M54 to M6 Link Road
TR010054
Volume 8
8.7 Consultation Statement – Proposed
Scheme Changes

8.7 Consultation Statement – Proposed Scheme Changes Appendices Part 1 (B and C)

M54 to M6 Link Road CONSULTATION ON PROPOSED CHANGES TO THE DEVELOPMENT CONSENT ORDER APPLICATION 24 AUGUST 2020 TO 23:59 21 SEPTEMBER 2020

C1 Proposed Changes Consultation Brochure

C4 Scheme Changes Technical Drawing 1

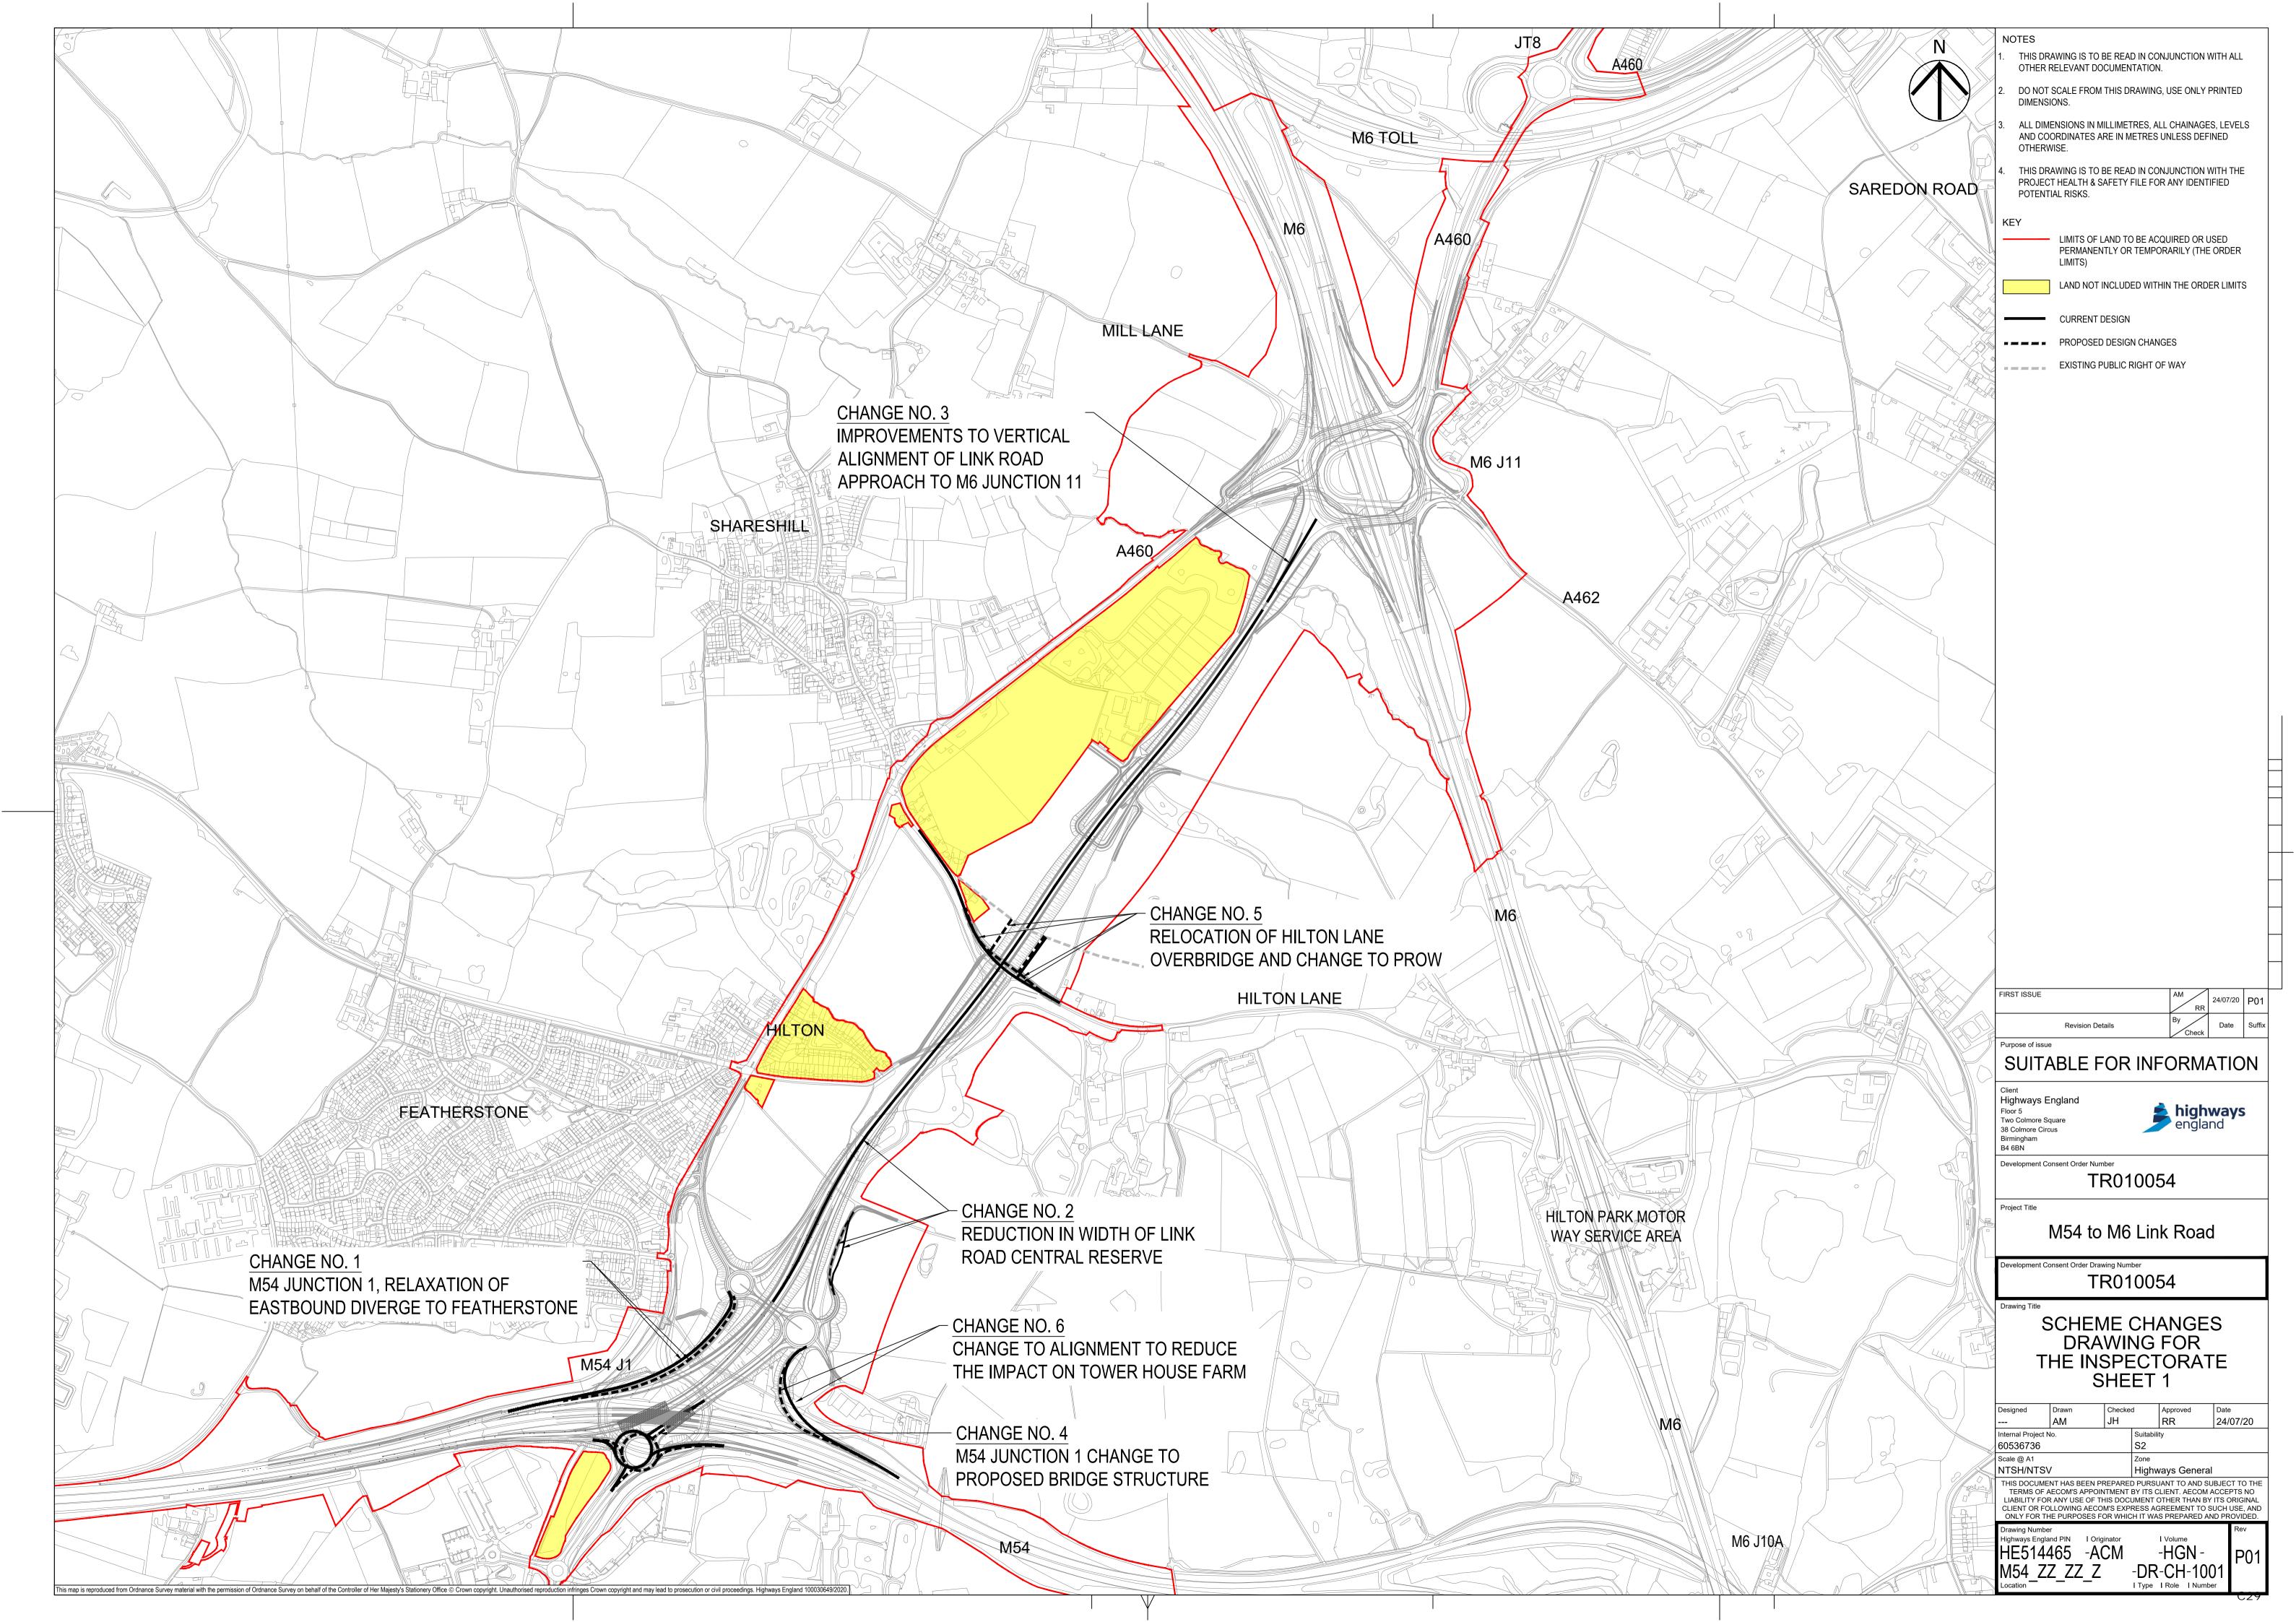
Change 1: Realignment of the eastbound slip road from the M54 at Junction 1 towards Featherstone, moving it further from Featherstone village.

We're proposing a minor realignment of the eastbound exit slip road to Featherstone, reducing the length of the slip road to the dumb-bell junction. This will bring the road closer to the junction and reduce the overall size of the junction.

Change 2: Reducing the width of the link road's central reservation and placing the drainage in the verge, rather than next to it.

The change will reduce the overall width of the link road by 4.2 metres and reduce the width of the slip roads at the junction to Featherstone.

Change 4: Change to bridge design and construction method at M54 Junction 1.

By building the bridge as two simpler structures, we can move the road alignment by 20 metres, which will reduce the size of Junction 1.

C5 Scheme Changes Technical Drawing 2

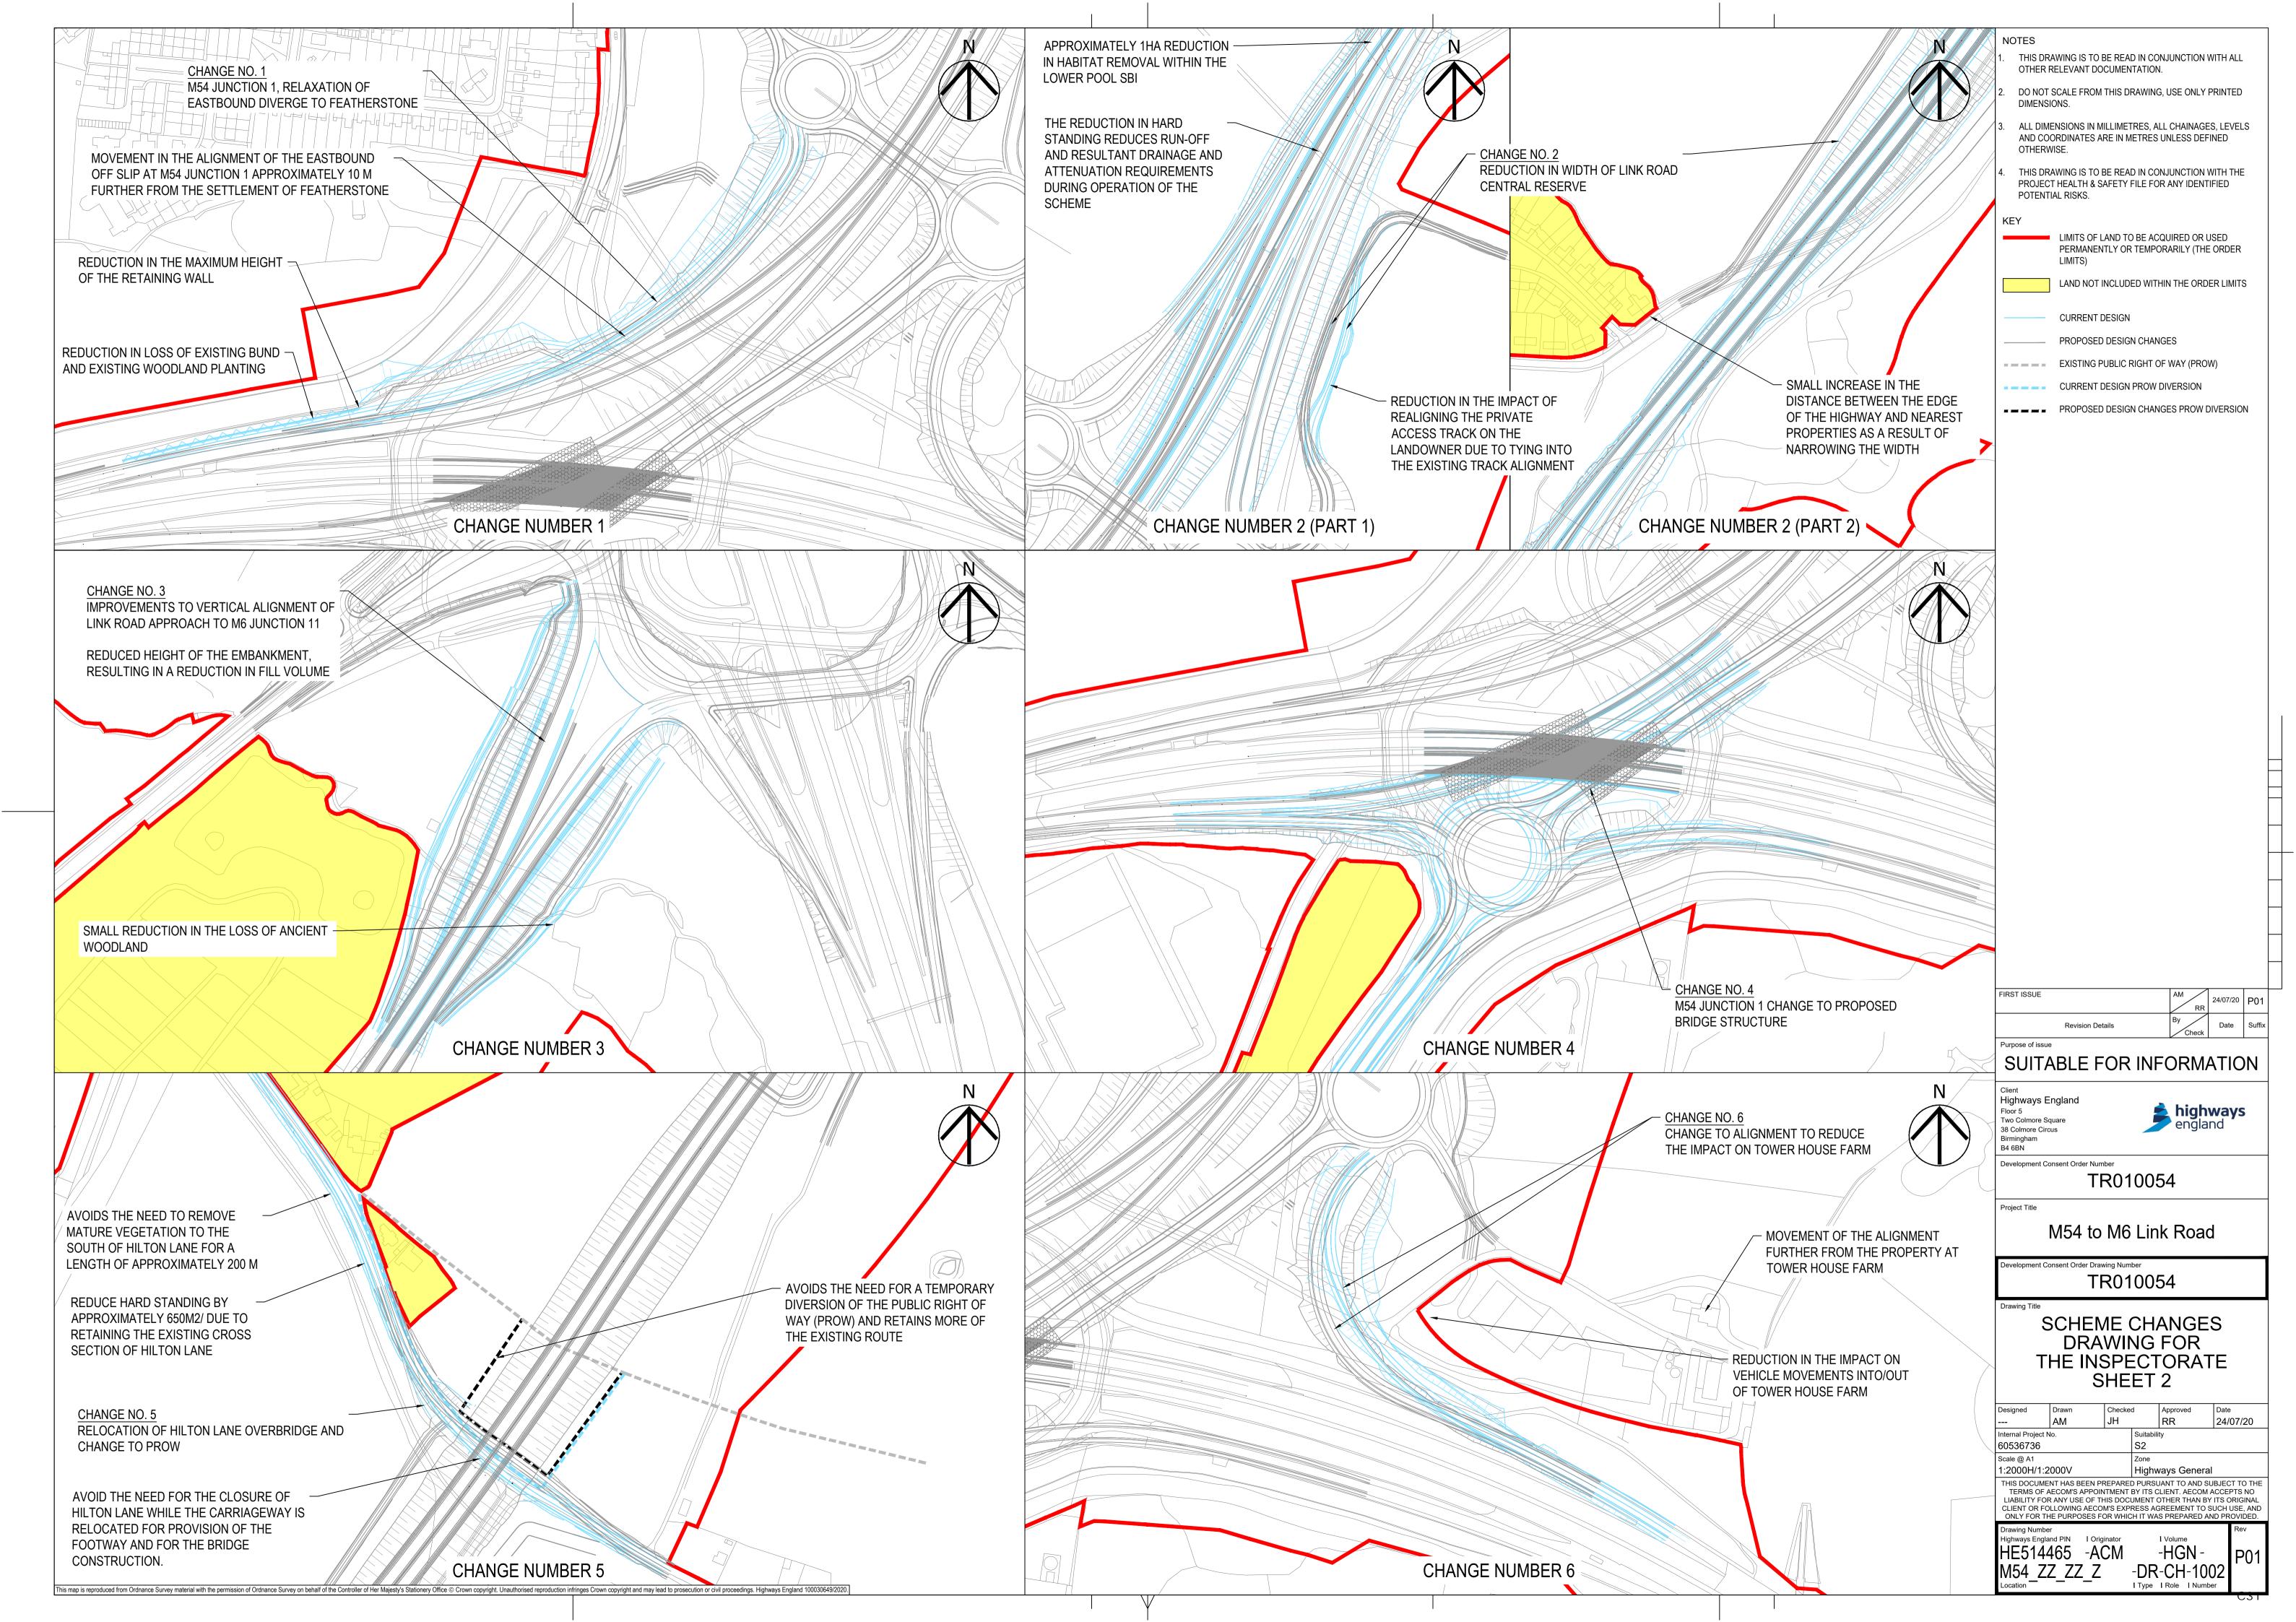
Please refer to the next page for a plan showing the closure points on the junction and the potential diversion routes. **Change 5:** Relocation of the new bridge over the proposed link road at Hilton Lane and change to route of nearby Public Right of Way.

Following further work to review how we build the scheme, we're proposing to build the Hilton Lane bridge to the north of its current proposed location. This proposed change will enable us to keep more of the existing route of the Public Right of Way (PRoW) [Shareshill 5] across nearby land rather than route it alongside the link road as is currently proposed in the application.

The proposed change would keep the PRoW so it follows more of the existing route, before travelling south towards Hilton Lane, across the new bridge, then diverting north to tie into its existing alignment to the west of the new link, where it would continue westwards and link into Hilton Lane.

Change 6: Change in alignment of the slip road at the revised M54 Junction 1 leading on to M54 eastbound.

As a consequence of proposed change 2 and following engagement with a local landowner, we're proposing to move the alignment of the slip road between the M54 Junction 1 eastern dumbbell roundabout and the M54 eastbound to the west of the position shown in the DCO application. This change minimises the impact on occupiers and users of Tower House Farm.
